REQUEST FOR AMENDMENT  
FACILITY OPERATING LICENSE DPR-75  
UNIT NO. 2  
SALEM GENERATING STATION  
DOCKET NO. 50-311

PROPOSED CHANGE  
AXIAL FLUX DIFFERENCE  
TECHNICAL SPECIFICATION  
SALEM UNIT NO. 2

FIGURE 1  
Salem Unit 2 Cycle 1  
Mode A Only  
(18 Case FAC Analysis)

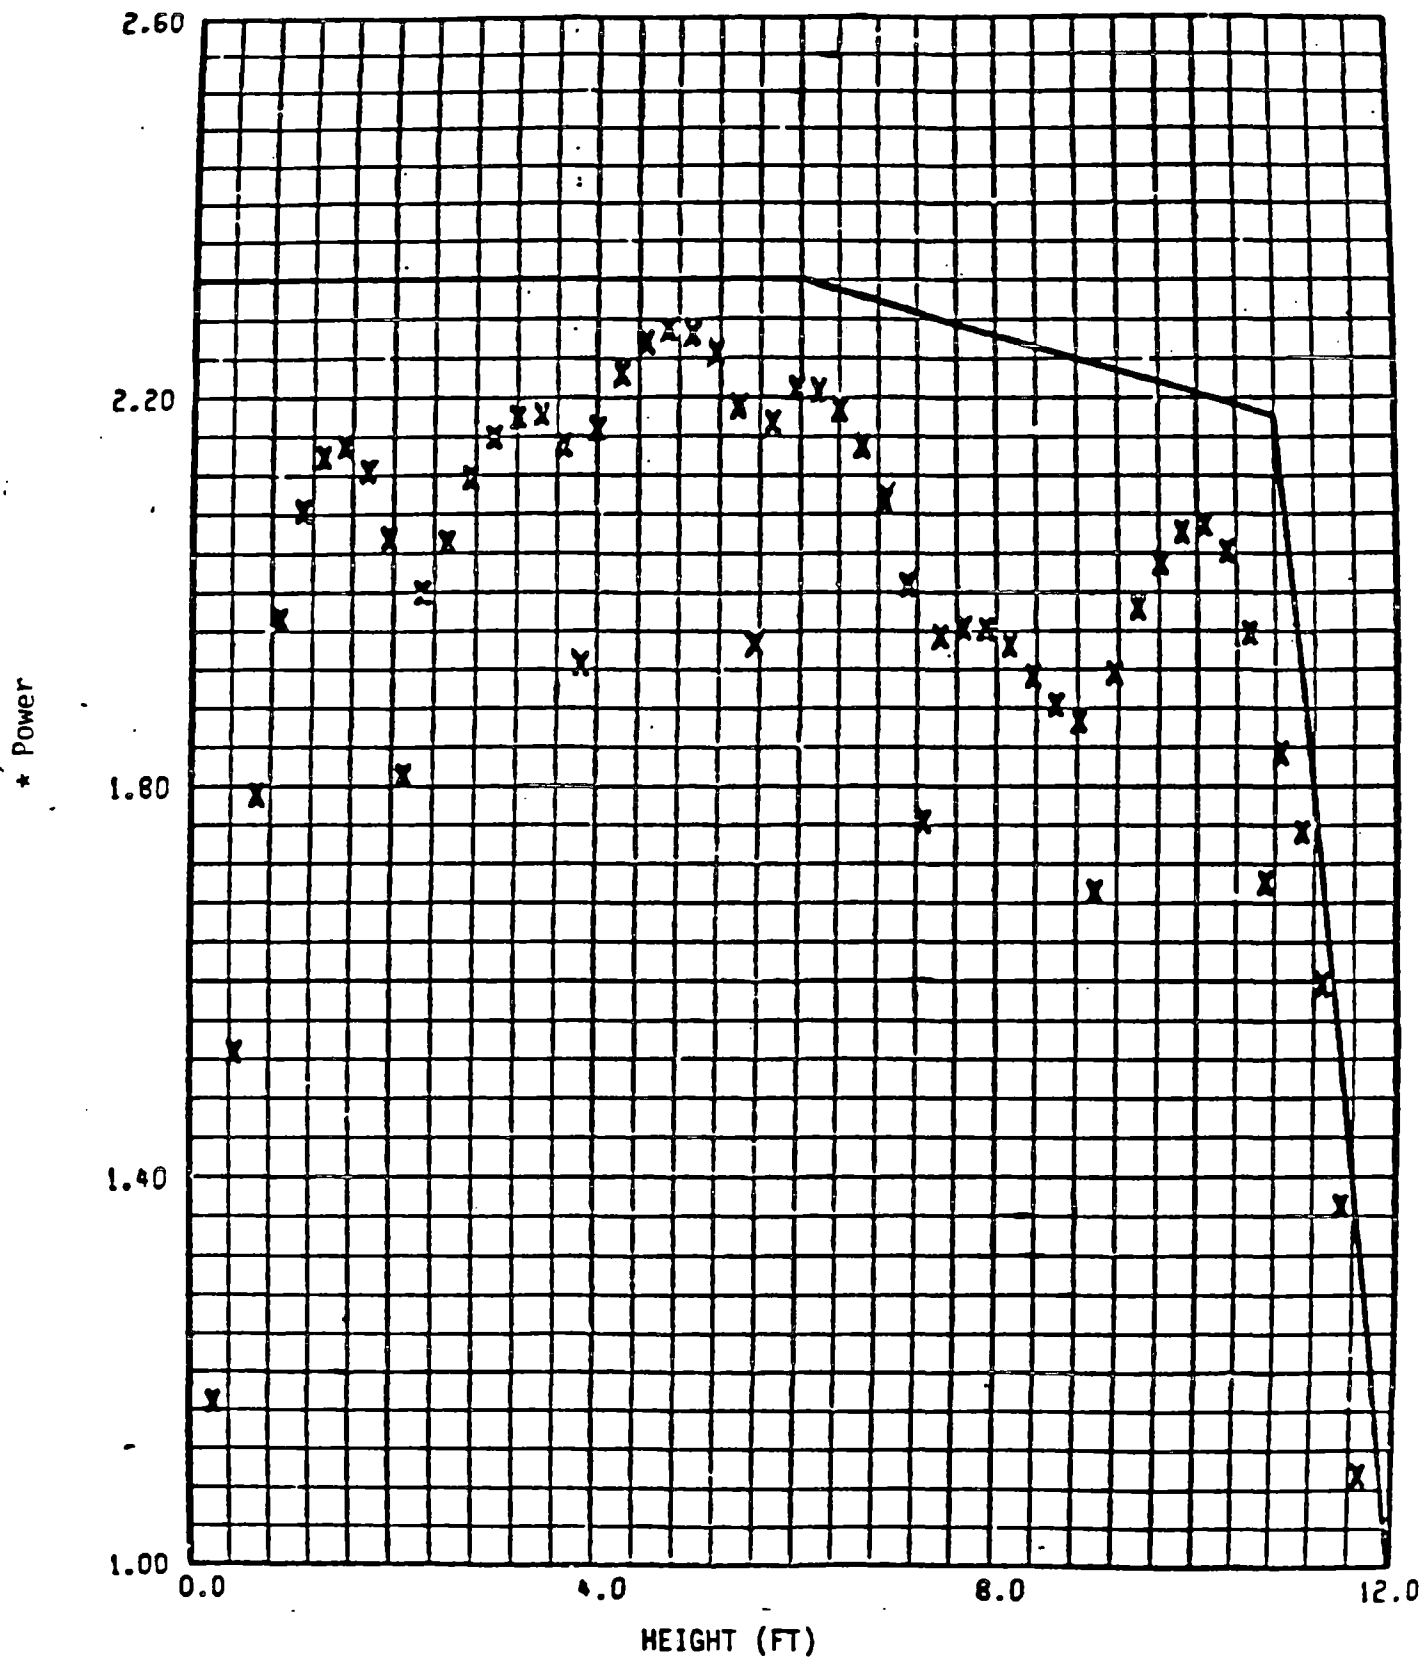
Change the axial flux difference target band to +6, -9% about the target flux difference.

Increased flexibility for operating the unit under Constant Axial Offset Control (CAOC), especially during power change maneuvers.

An analysis of total peaking factor versus core height for normal plant operation has been performed for Salem Unit 2 cycle 1. The bases for the analyses included CAOC with +6, -9% $\Delta I$  control band and that the limit on  $F_{xy}$  at fractional thermal power was modified to include a multiplier change from 0.2 to 0.3. The power peaking calculations were performed using the 18 case analysis discussed in the "Westinghouse Reload Safety Evaluation Methodolgy", WCAP9273, and documented in a Westinghouse letter from C. Eicheldinger to D. B. Vassallo of the NRC (NS-CE-687 dated July 16, 1975). NRC approval to use the 18 case analysis for  $\Delta I$  bandwidening was given in a letter from D. B. Vassallo to C. Eicheldinger, dated April 15, 1976. The results of these calculations are shown in figure 1. It can be seen that  $F_{xy} \times \text{Power}$  satisfied the generic FAC boundry with the +6, -9% $\Delta I$  target band and the revised multiplier on the  $F_{xy}$  limit at fractional thermal power. Therefore, the peaking factor and DNBR criteria are met with margin for the +6, -9% $\Delta I$  band and revised  $F_{xy}$  limit at fractional thermal power.
